Agenda Item #2

Application 2024-13-CA

30 Hannon Avenue

Revise fenestration plan for south elevation and east entry door.

3. South elevation, post alterations

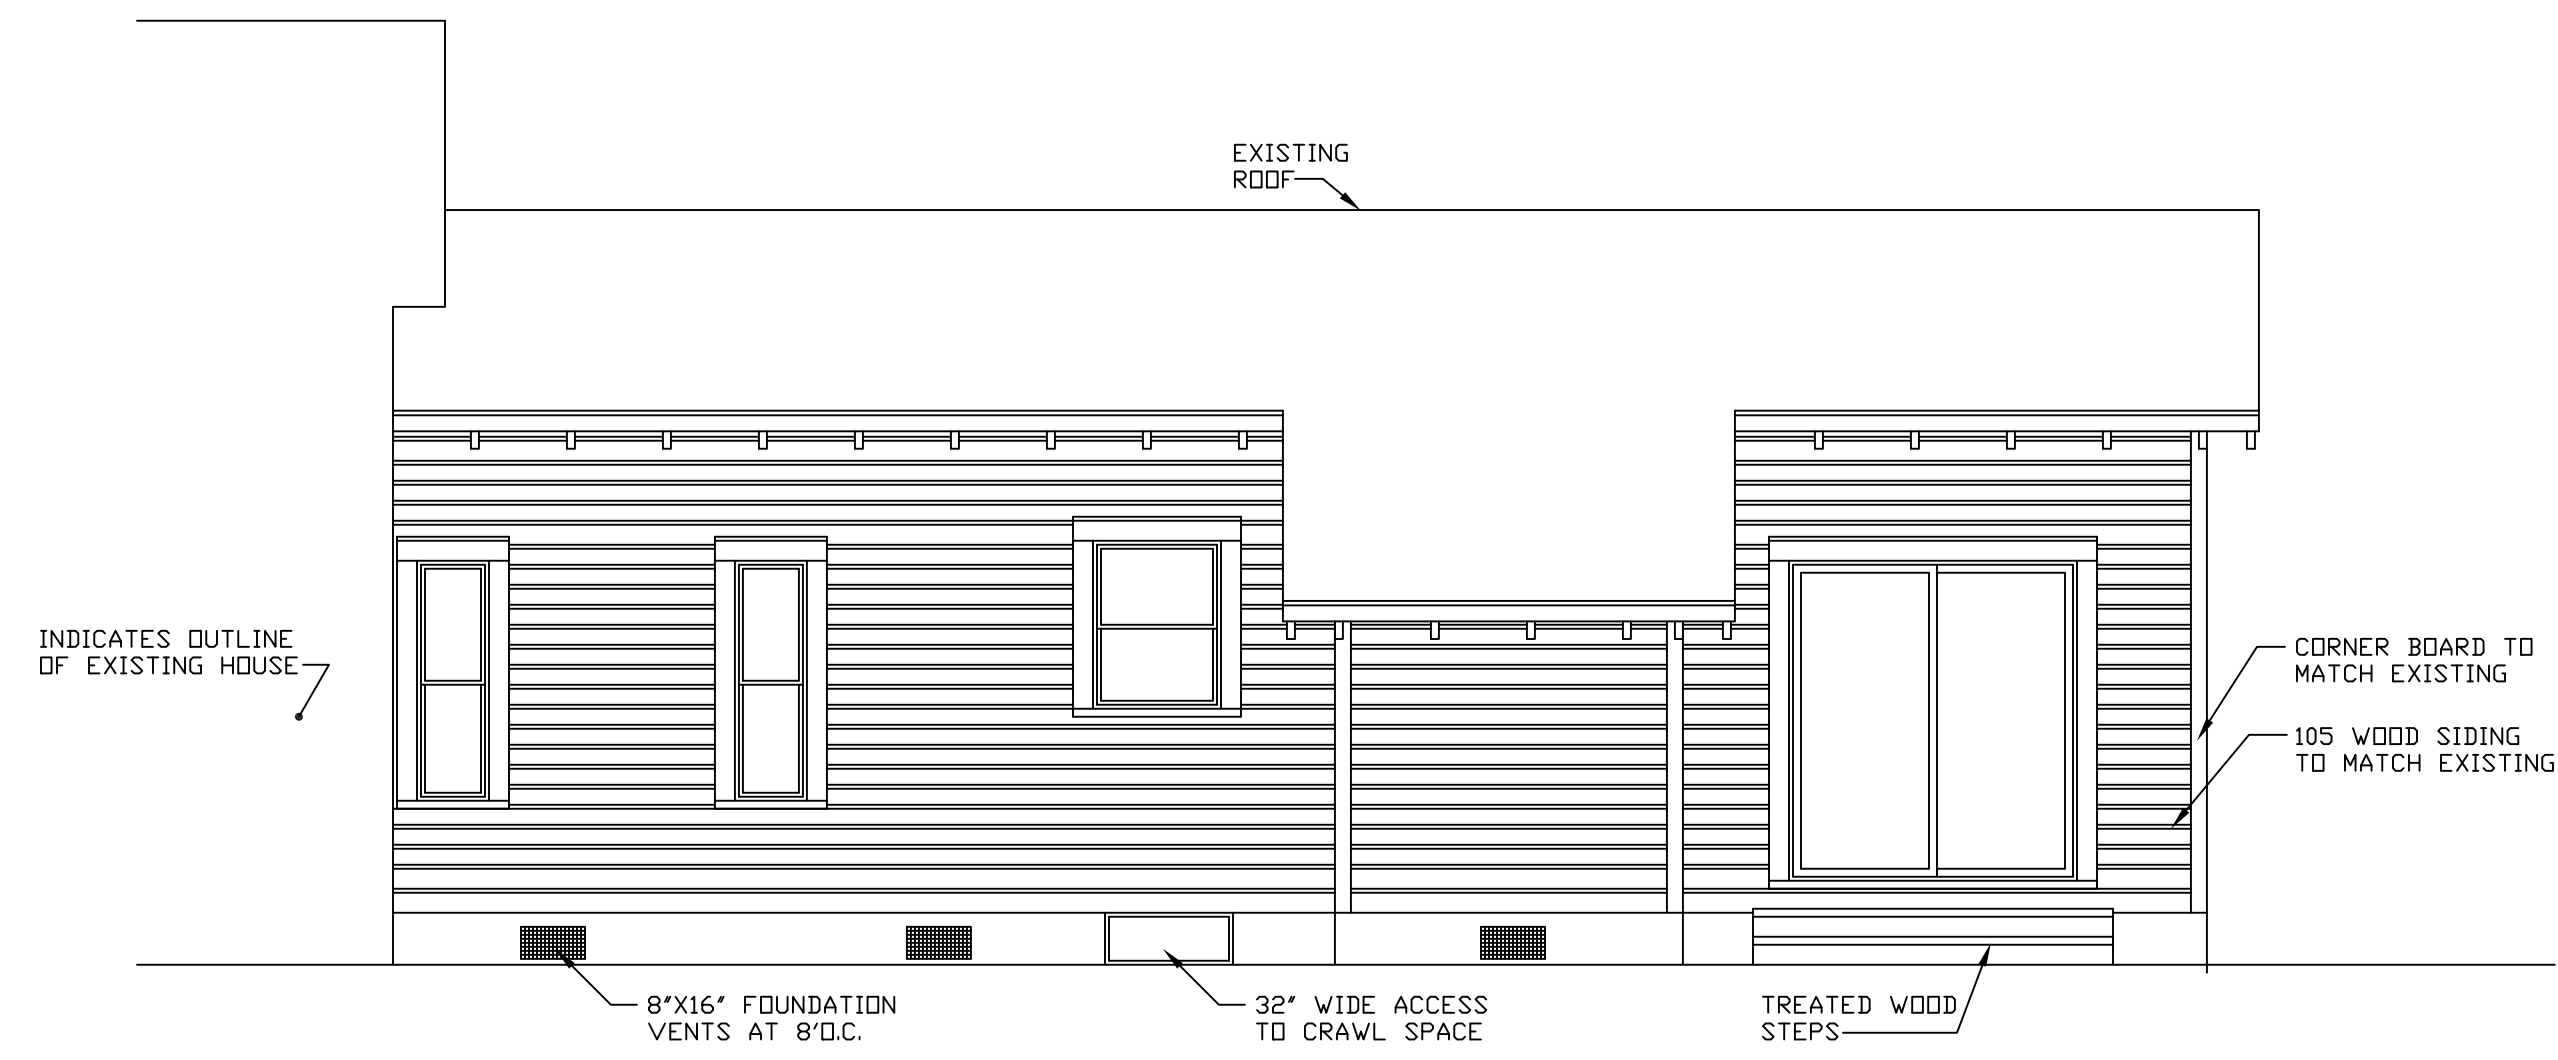
east elevation of the addition (see Photo 3) is not located on a primary façade and somewhat echoes the prairie style divided light entry door on the main façade. However, vinyl is not listed as an acceptable material for historic buildings. Further, the sliding glass door on the north elevation is not compatible with the historic character of the property or district. (5.15)

LEFT SIDE EXTERIOR ELEVATION

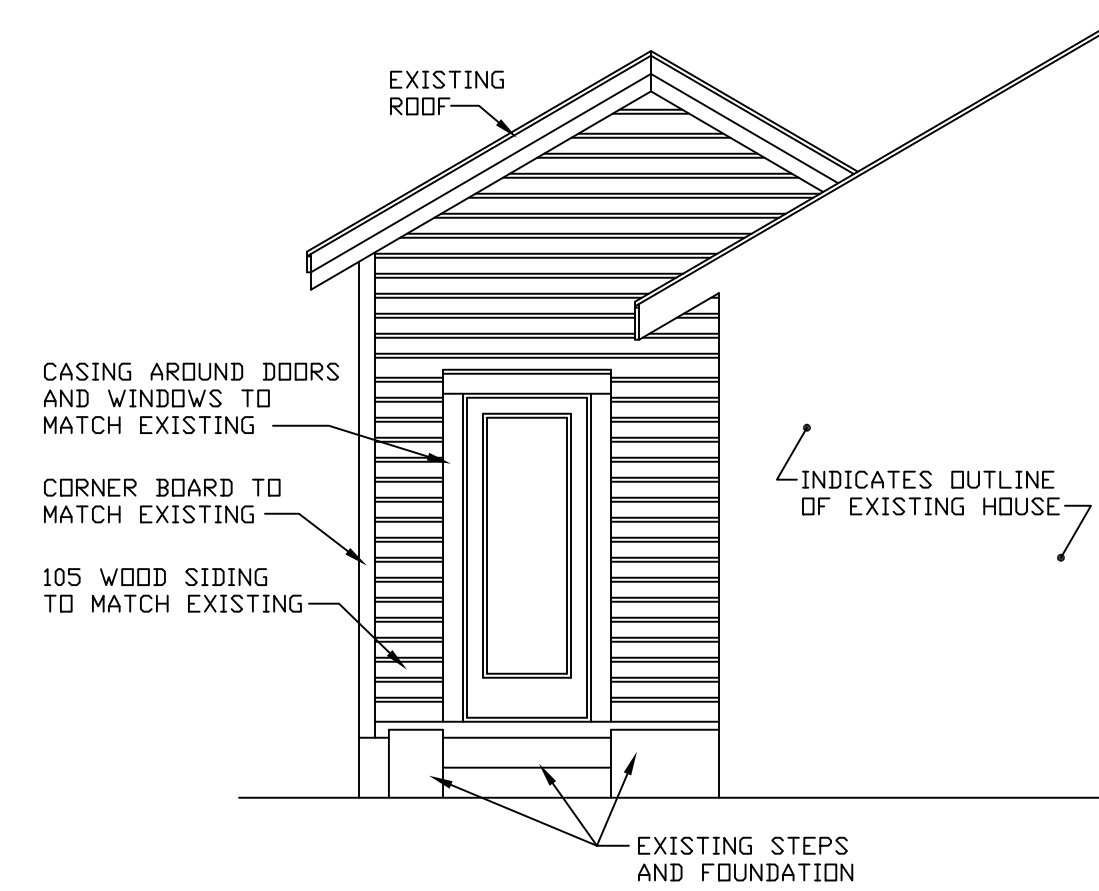
The original windows on the south elevation had been removed and replaced with 6" wood siding and one four-light transom wood window measuring 40" wide by 12" high, located on the upper east end of the elevation. The new plans propose a more traditional fenestration pattern which includes the installation of two fixed dummy windows represented as closed louvered shutters, and one six-over-one aluminum clad sash window. The new elevation drawings do not reflect the suggested changes for the east elevation's entry door. However, the applicant has submitted a manufacturer's cut sheet of a multi-light aluminum clad entry door.

The proposed fenestration alterations employ more appropriate window materials, design, size and profile across the south elevation, creating the appearance of a more traditional rhythm which better communicates with the historic addition and the original structure. (5.7, 5.20-22) Likewise, the proposed replacement entry door for the east elevation better reflects the age and style of the buildings, as directed in the *Guidelines*. (5.15) The shutter material needs to be specified prior to making a decision on the application.

▲ REMOVED TRANSOM WINDOW AND INSTALLED FIXED SHUTTERS AND 3050 WINDOW AT LEFT SIDE EXTERIOR ELEVATION.
